# Access Compliance Report

## Public Rights-of-Way

### (Curb Ramps)

Intersection ID: 30613	Main Street: GOLF_LINKS_DR	Cross Street: PROVIDENCE_RD	Location: SW
ADA ID: 072B7E612924	Ramp Type: Perp	Initial Pass/Fail: Fail	Overall Compliance: No
			Severity Score: 13.75

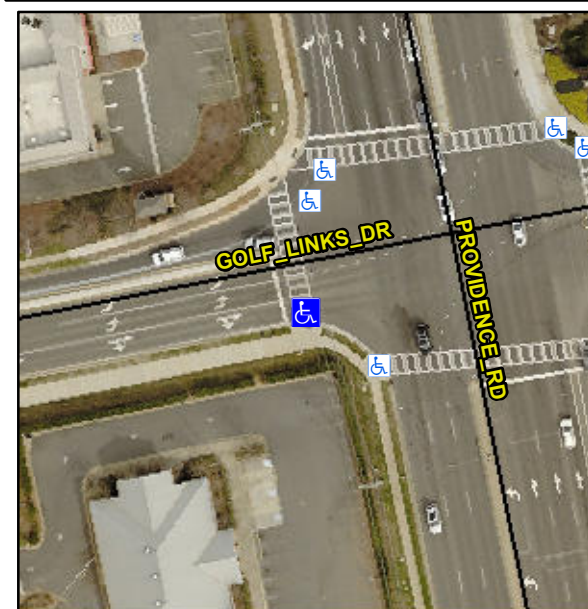
**Not Found, R304.2.2, R304.5.3**

Compliance	Description	Data	Compliance	Description	Data
N/A	Ramp Length (in)	46.0	No	Ramp Slope (%)	9.8
Yes	Ramp Width (in)	59.0	No	Ramp XSlope (%)	3.2
N/A	Flare Type LT	N/A	N/A	Flare Type RT	N/A
N/A	Flare Slope LT (%)	N/A	N/A	Flare Slope RT (%)	N/A
N/A	Flare Traversable LT?	N/A	N/A	Flare Traversable RT?	N/A
N/A	Landing Length (in)	N/A	N/A	DWS Provided?	N/A
N/A	Landing Width (in)	N/A	N/A	DWS Contrast?	N/A
N/A	Landing Slope (%)	N/A	N/A	DWS Length (in)	N/A
N/A	Landing X Slope (%)	N/A	N/A	DWS Full Width?	N/A
N/A	Landing Curb? (Y/N)	N/A	N/A	DWS Offset (in)	N/A
N/A	Shared Landing?	N/A			
N/A	Gutter Ponding?	N/A	N/A	Gutter Slope (%)	N/A
N/A	Gutter Lip Ht (in)	2.0	N/A	Gutter X Slope (%)	N/A
N/A	Painted X Walk1?	No	N/A	Painted X Walk2?	N/A
	X Walk 1 Direction	To N		X Walk 2 Direction	N/A
N/A	X Walk 1 Width (in)	N/A	N/A	X Walk 2 Width (in)	N/A
	X Walk 1 Slope (%)	0.8		X Walk 2 Slope (%)	N/A
	X Walk 1 X Slope (%)	2.6		X Walk 2 X Slope (%)	N/A

**Remove & Replace Entire Ramp.**
